Groundwater Application Review Summary Form

Application # G- 19161

GW Reviewer Jen Woody Date Review Completed: 3/24/2023

TO: Water Rights Section Date 3/24/2023
 FROM: Groundwater Section Jen Woody
 Reviewer's Name
 SUBJECT: Application G- 19161 Supersedes review of 9/15/2021
 Date of Review(s)

G-19161 Vang and Moua: 4S/3W-Section 6

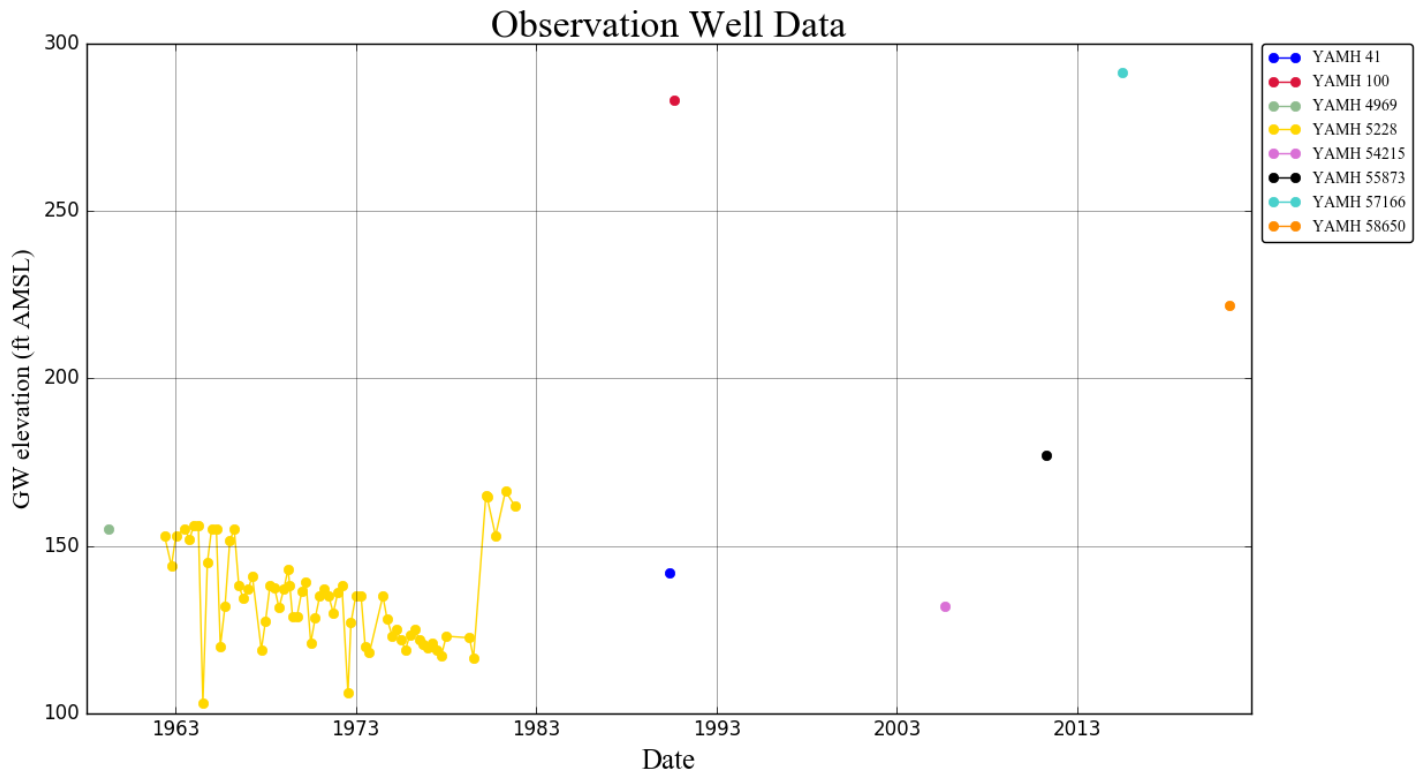
The proposed POAs (Wells) are completed in the low-yield bedrock aquifer; median yield in this section is 10 gallons per minute. Nearby, long-term water level data are sparse. Well density in the bedrock aquifer is relatively low (36 new well logs in the section. Although the likely anisotropy of the aquifer makes it difficult to predict the potential for interference with existing wells, the general low yield of the aquifer indicates that it would be prudent to include water-level monitoring and water-use monitoring conditions. **Special Condition: For the same reasons, a condition is recommended to limit the maximum duty to 1 acre foot per acre per year and a requirement to use drip, or equally efficient, irrigation methods if a permit is issued (see OAR 690-502-0040(7)).**

Comments: The proposed wells are hydraulically connected to and less than ¼ mile from a spring and tributary to Henry Creek, which triggers the assumption of PSI as defined in OAR 690-09-040.
